OWNER:  شرکت سست و سوبی توهمه ایران (سهامی خاص)	BUSHEHR PETROCHEMICAL COMPANY MEG PLANT							EPC CONTRACTOR:  Chagalesh-Enerchimi-Steam Joint Venture BUPC-MEG PLANT PROJECT	
	SIL REPORT							 Netherlands	
MC :   شرکت سست و سوبی توهمه ایران (سهامی خاص)	Project	Area	Phase	Unit	Dis.	Doc.	Seq.	Contract No : 52-98/445	
Owner Document Number: 17811-78	BU	20	VD	303	QC	REP	0105	Rev.:	Page
								02	1 of 48

HAZOP / SIL REPORT

**BUPC MEG Plant HAZOP & SIL Report –
N2 and Air Compressor
Detailed Design**

Client Report No: BUPC-17811-OO-0703

DRAWING TITLE: 17811-03 P&ID FOR NITROGEN GAS BOOSTER

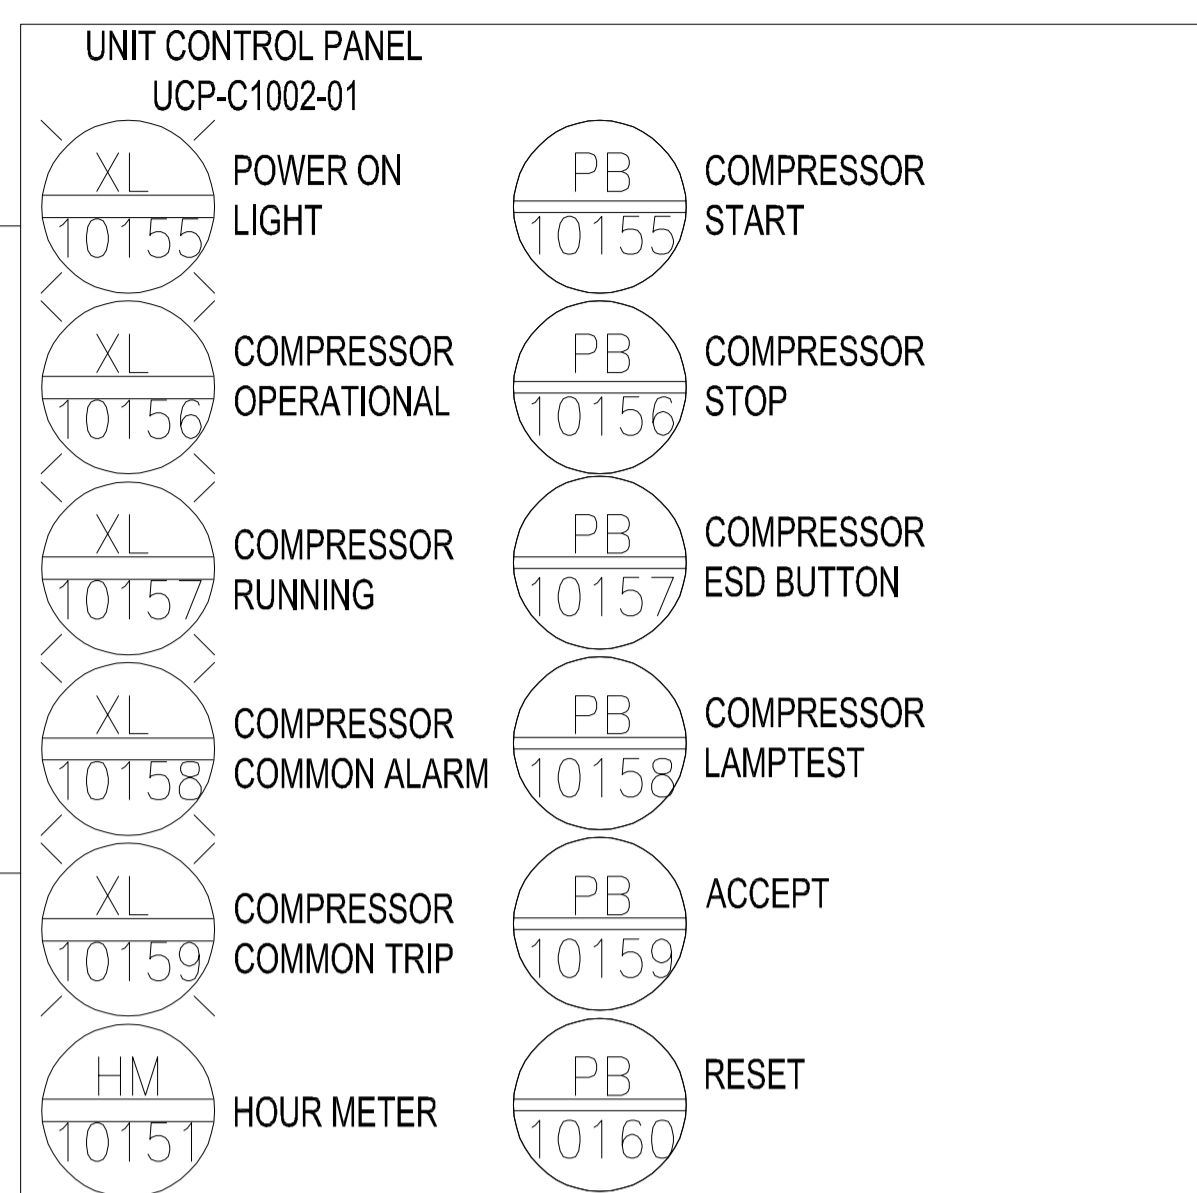
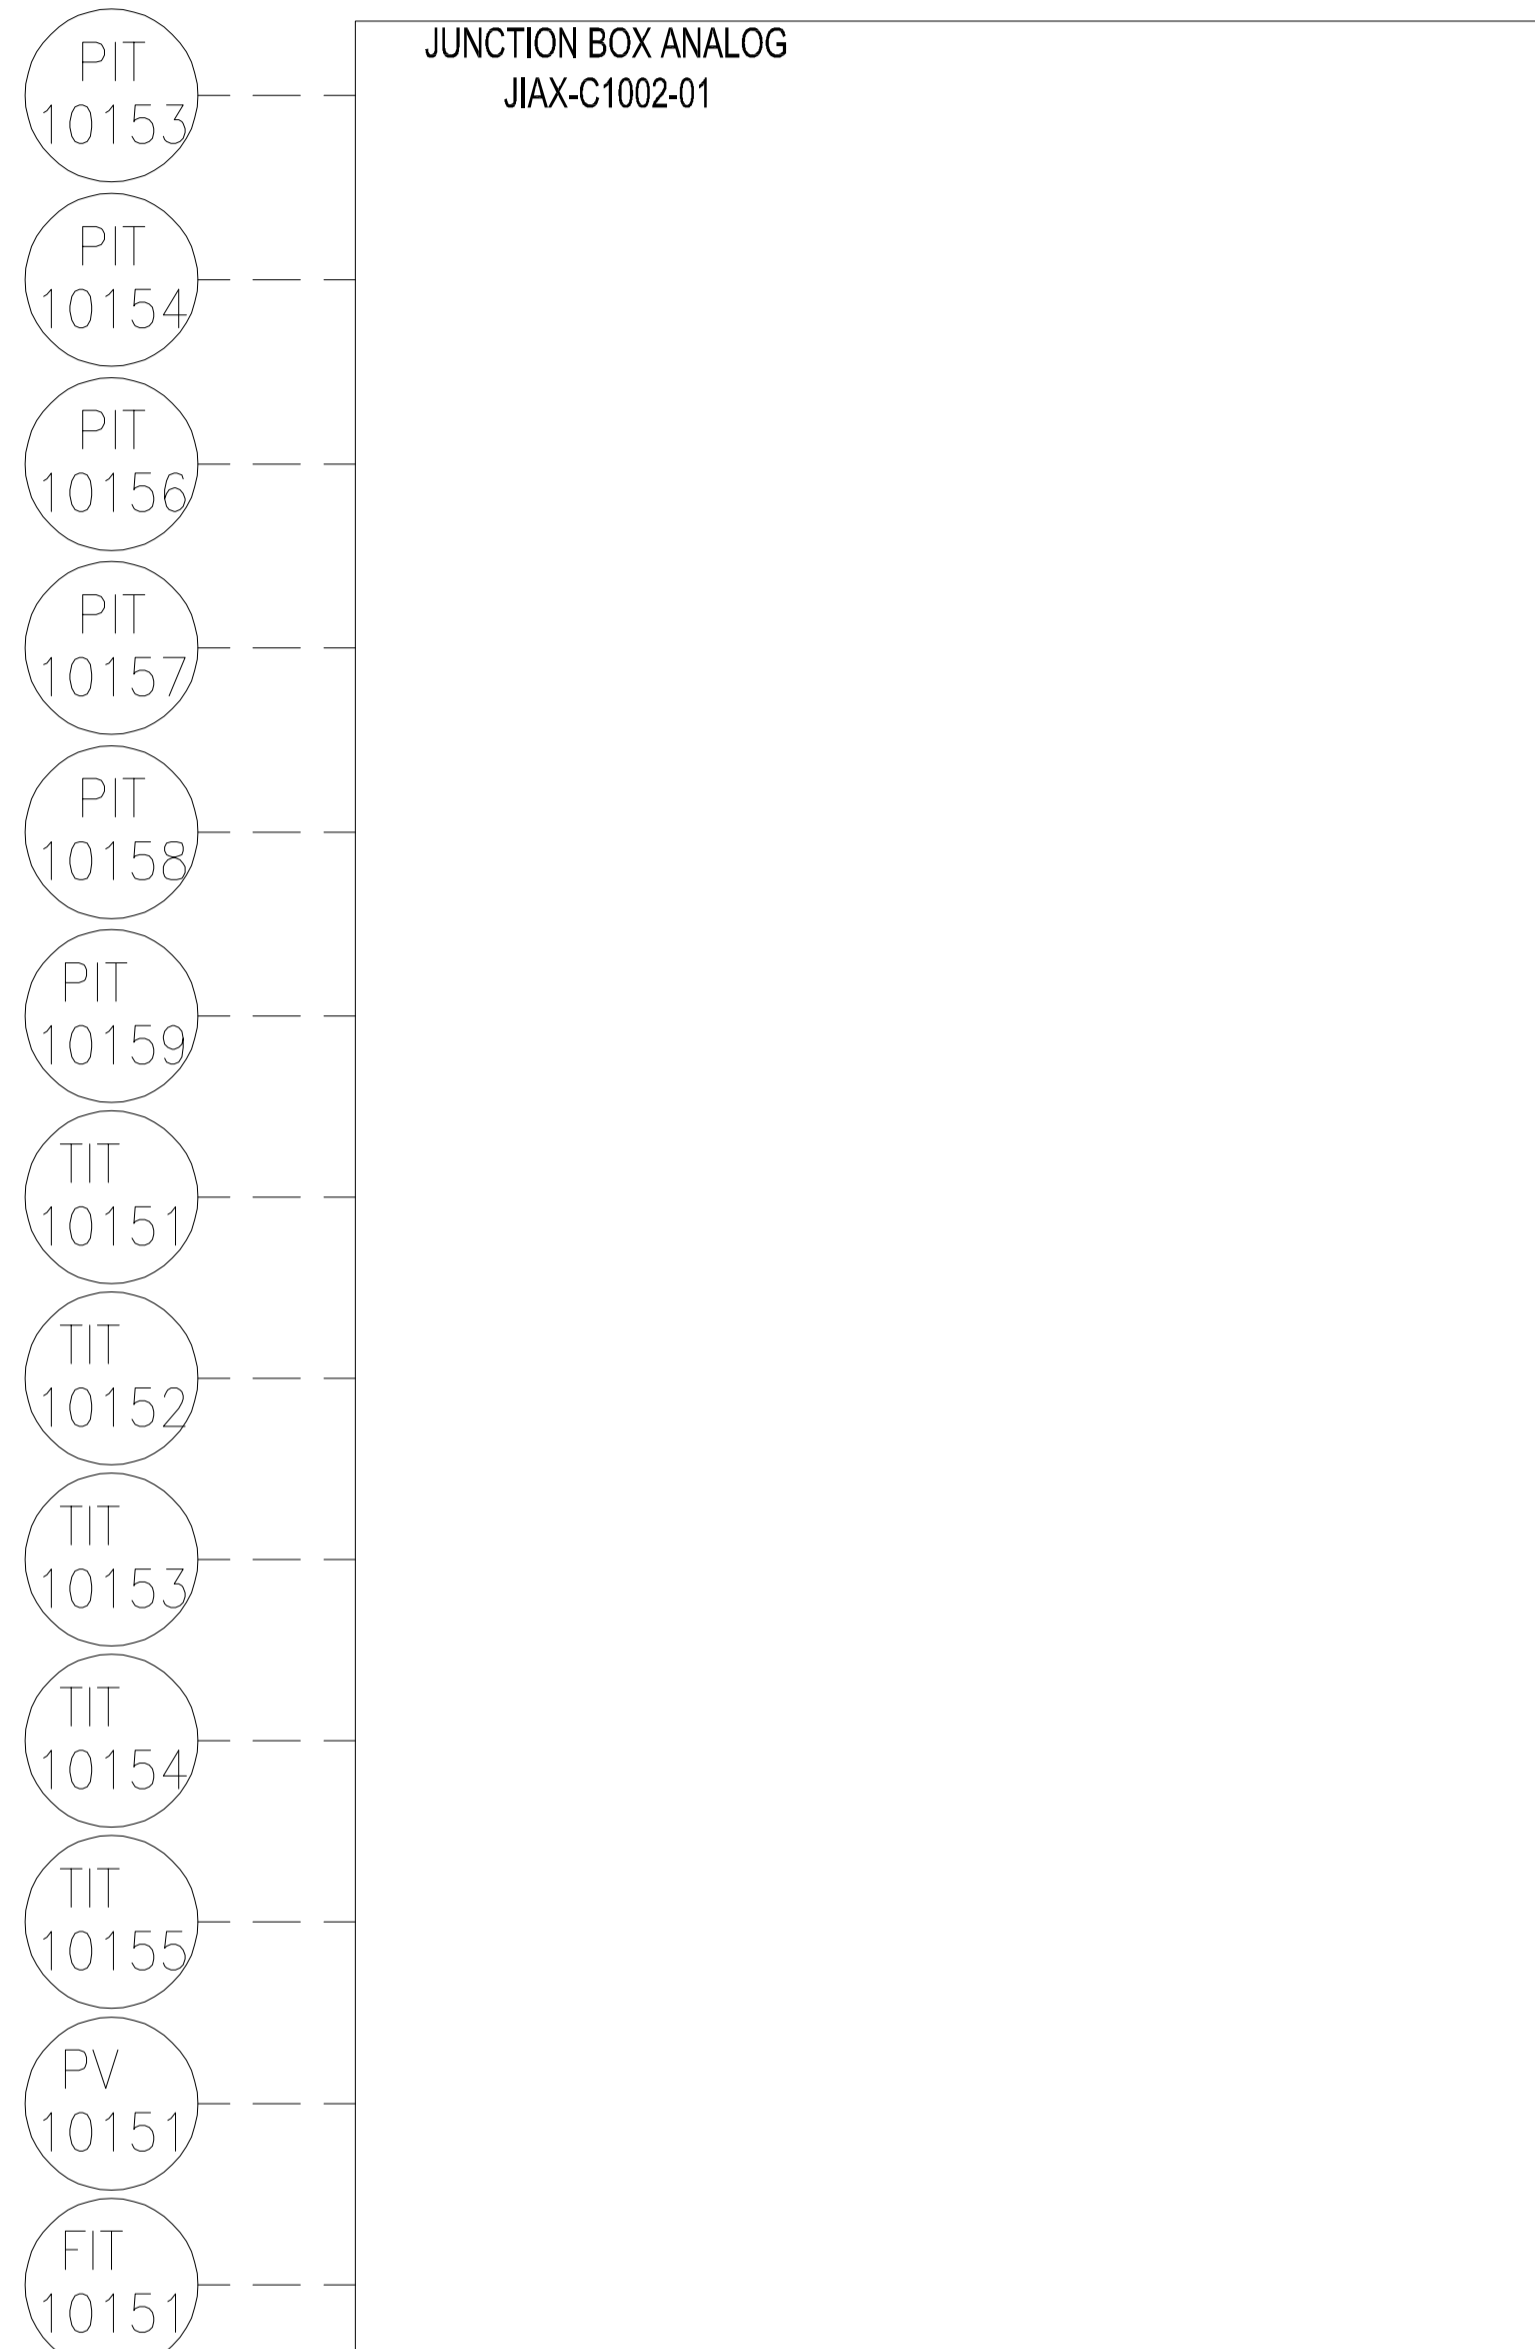
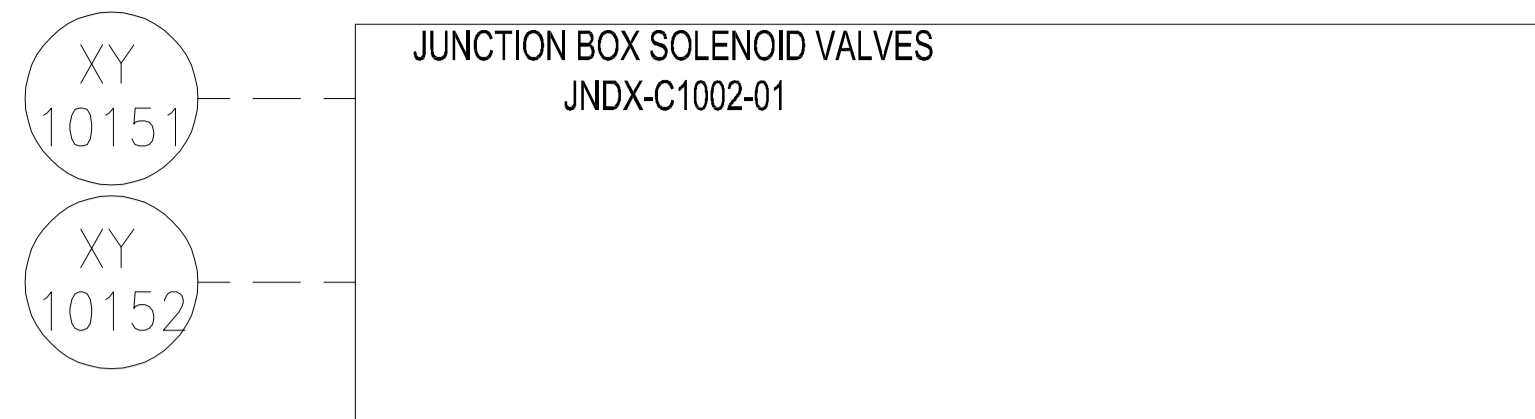
Node 1: Nitrogen

Node 2: Cooling Water N2 Compressor

01.1.1.1	Flow	No / Not	No/Less Flow	No nitrogen supply from Plant	1. No Supply to the compressor leading to underpressure at the suction side of the compressor. Worst case is if recycle line is closed. No vacuum is expected, however the 1stage discharge pressure will decrease. Increase of temperature of the second stage exceeding the design temperature of the Compressor. Less supply to the end users. Vibrations of the axis of the compressor is possible. No loss of containment. No hazardous consequence. Asset damage (L) only 2nd stage < 5000 US\$.	L	1. PIT-10153-PALL to Trip 20-C-1002 (UCP ESD) 2. PIT-10159-PALL to Trip 20-C-1002 (UCP ESD) 3. TIT-10155-TAHH to trip 20-C-1002 (UCP ESD)	1	3	SIL 0	1. PIT-10153-PALL to Trip 20-C-1002 (UCP ESD) 2. PIT-10159-PALL to Trip 20-C-1002 (UCP ESD) 3. TIT-10155-TAHH to trip 20-C-1002 (UCP ESD)	3	No action

02.1.1.4	Flow	No / Not	No/Less Flow	No Cooling Water supply from Plant	Overheating of cooling water in aftercooler 20-AEC-1002-2. Exceeding of the design temperature of the tubes inside the aftercooler (95 deg C). Maximum temperatures of the cooling water (140 deg C -equal to uncooled nitrogen- can be reached. Boiling of water may start at ca. 120 deg C. Tube rupture is possible. Nitrogen induced into the cooling water and exceeding also the design pressure of the cooling water system. Loss of containment is possible. Maximum release with full rupture- 0.2 kg/s (707 kg/h /). Full rupture is not expected. No suffocation of people is expected (open area, 4 sides open). Remote suffocation risk to people is possible (safety distance is ca. 1-2 meters. Severity S=S2 (S2 is equal to C A according risk matrix) Asset damage (L) is ca. 10 k. US\$ L=S1; Most severe risk is people risk (S=S2).	S	1. TIT-10155-TAHH to Trip 20-C-1002 (UCP ESD) 2. FT-10151-FAL to Trip 20-C-1002 by operator (only 1 alarm is counting for a risk reduction) 3. PSV-10153 @3.5 barg to ground	2	3	SIL 1	1. TIT-10155-TAHH to Trip 20-C-1002 (UCP ESD) <i>SIL 1 SIF in SIS</i> 2. FT-10151-FAL to Trip 20-C-1002 by operator (only 1 alarm is counting for a risk reduction) 3. PSV-10153 @3.5 barg to ground (RRF=100)	4	No action

DRAWING TITLE: 17811-03 P&ID FOR INSTRUMENT AIR COMPRESSOR

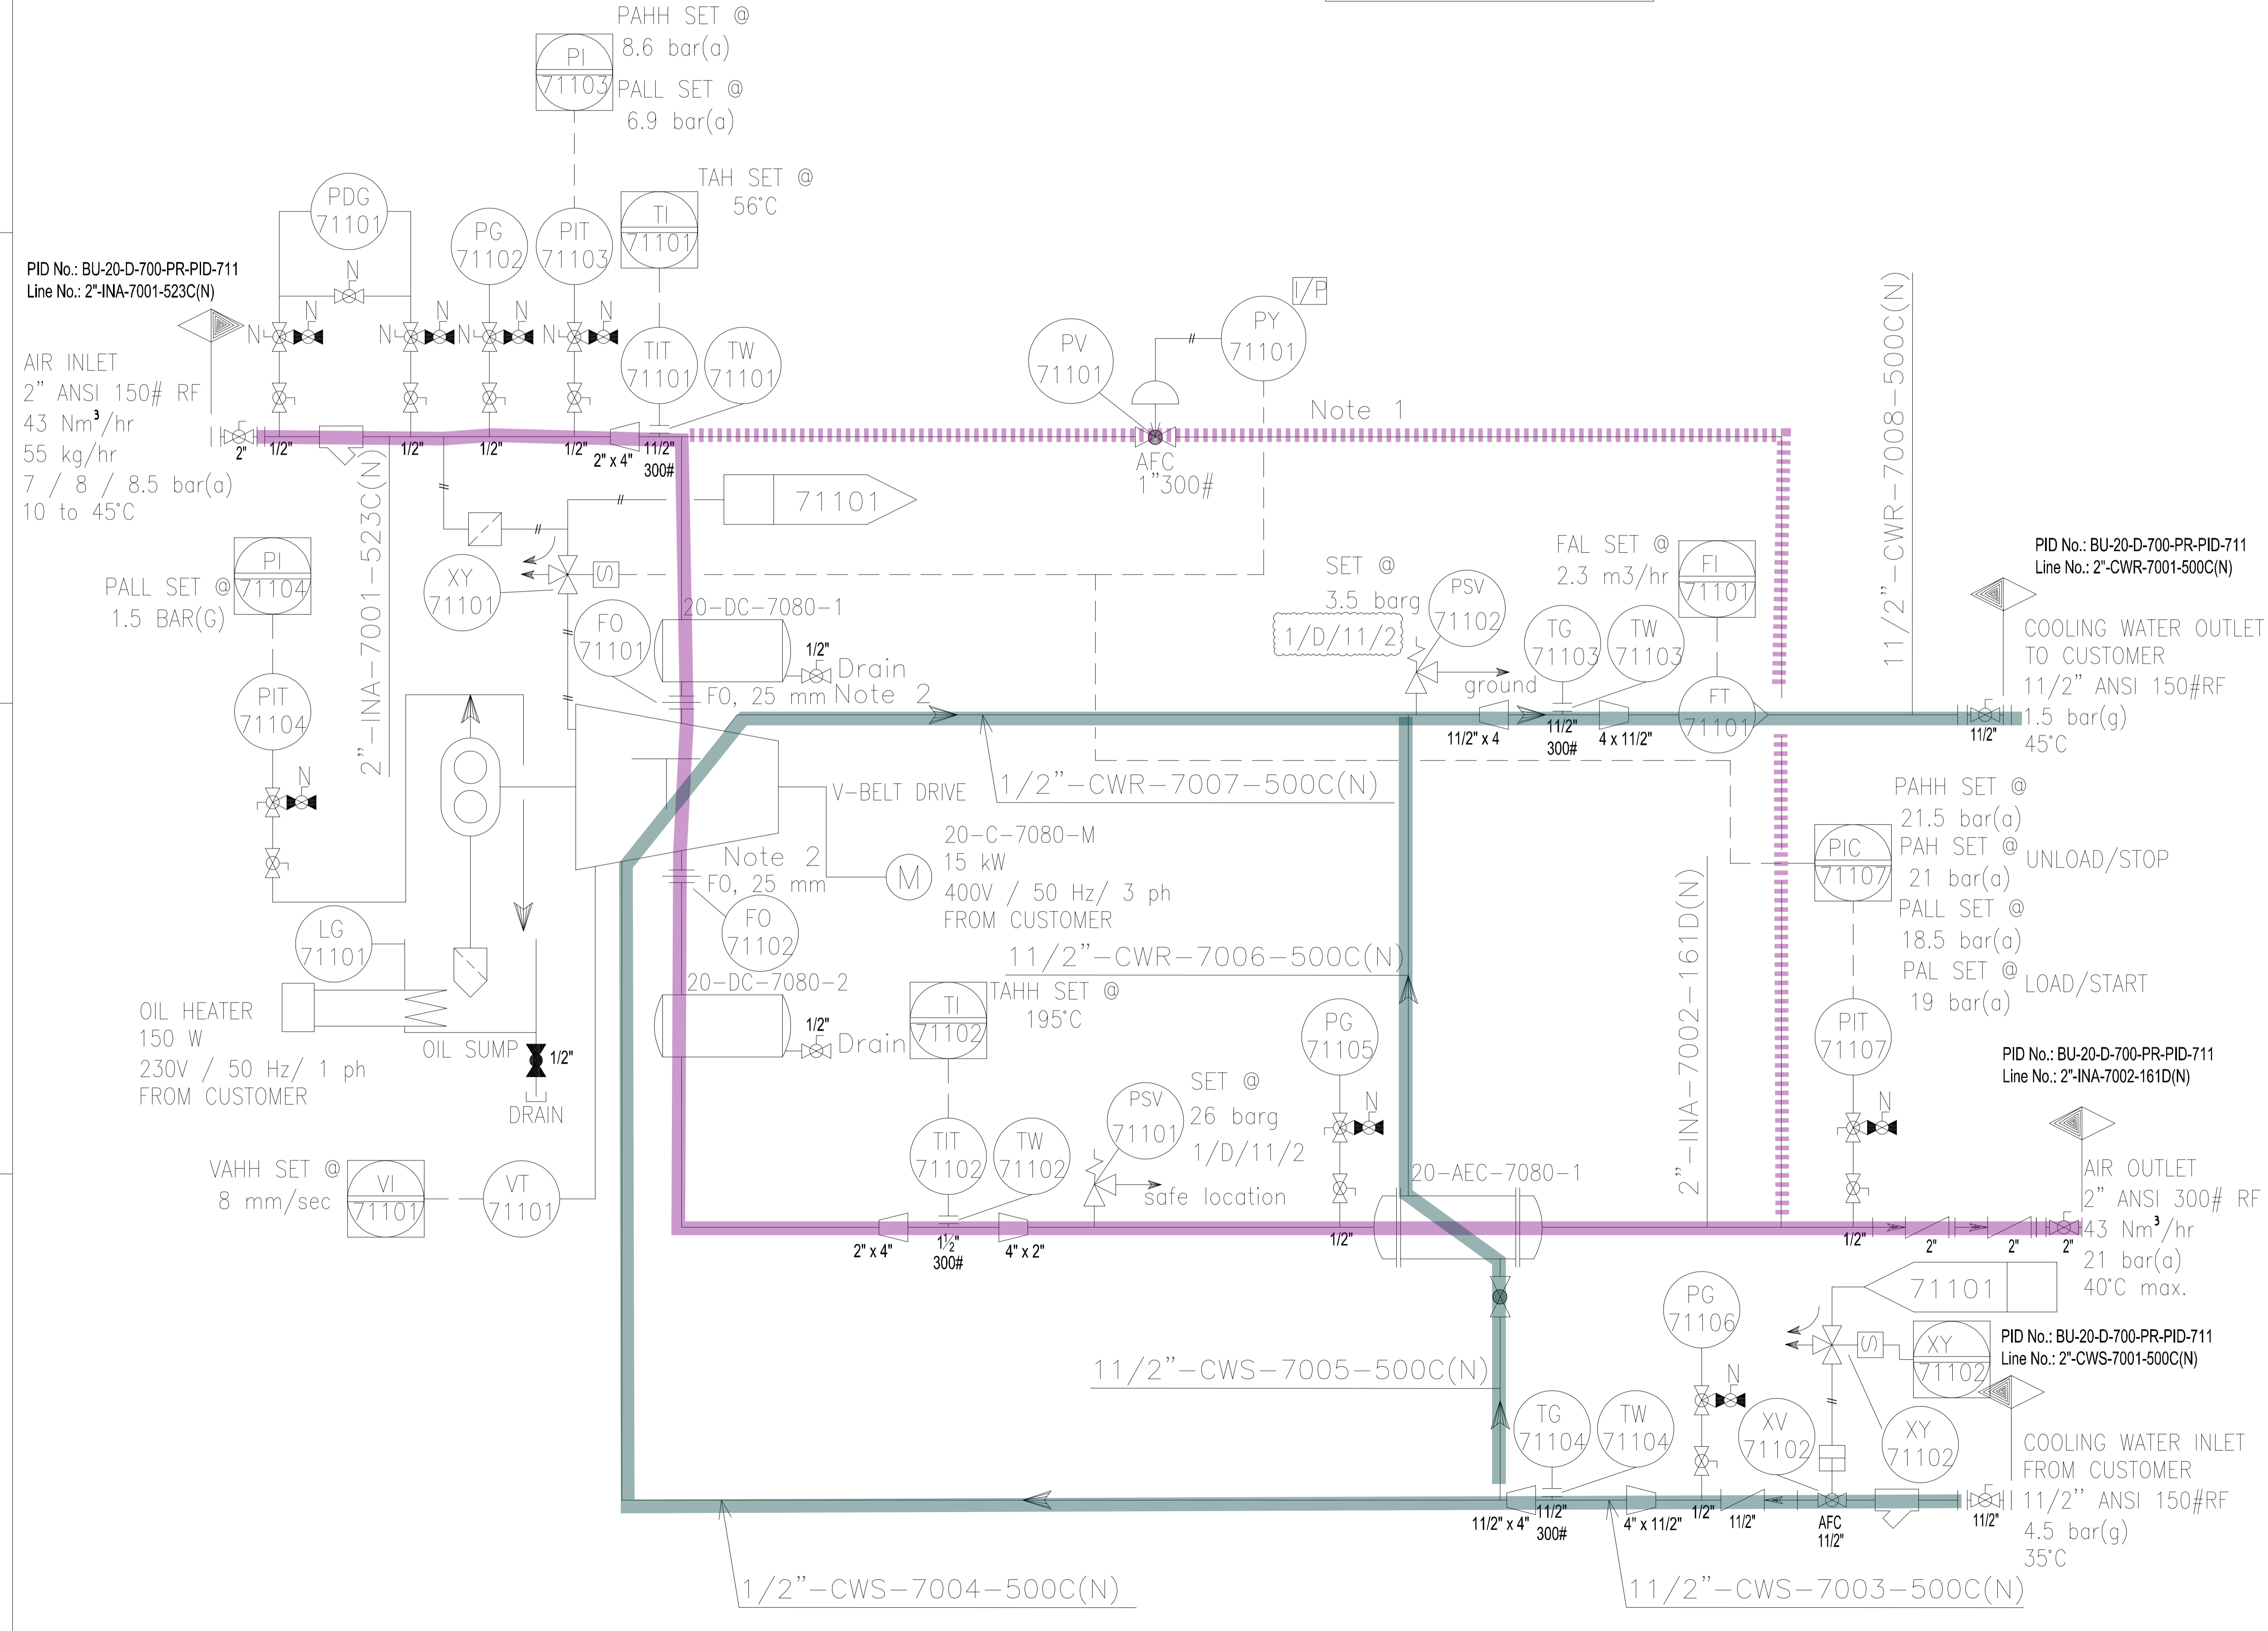
03.1.1.1	Flow	No / Not	No/Less Flow	No Air supply from Plant	1. No Supply to the compressor leading to underpressure at the suction side of the compressor. Worst case is if recycle line is closed. No vacuum is expected, however the discharge pressure will decrease. Increase of temperature of the first stage exceeding the design temperature of the Compressor. Less supply to the end users. Vibrations of the axis of the compressor is possible. No loss of containment. No hazardous consequence. Asset damage (L) < 5000 US\$.	L	1. PIT-71103-PALL to Trip 20-C-7080 (UCP ESD) 1. PIT-71107-PALL to Trip 20-C-7080 (UCP ESD) 3. TIT-71102-TAHH to trip 20-C-7080 (UCP ESD)	1	3	SIL 0	1. PIT-71103-PALL to Trip 20-C-7080 (UCP ESD) 1. PIT-71107-PALL to Trip 20-C-7080 (UCP ESD) 3. TIT-71102-TAHH to trip 20-C-7080 (UCP ESD)	3	No action

03.2.1.1	Flow	More	More/High Flow	More flow over the recycle line by 'Fail Opened AFC PV-71101 or control failure to opened valve in case AFC should be NOT fully opened.	1. Decreased pressure and temperature in the second stage of the compressor. Less supply to the plant/ end user. No hazardous consequence; No asset consequence.		1. PIT-71107-PALL to trip 20-C-7080 (UCP ESD)
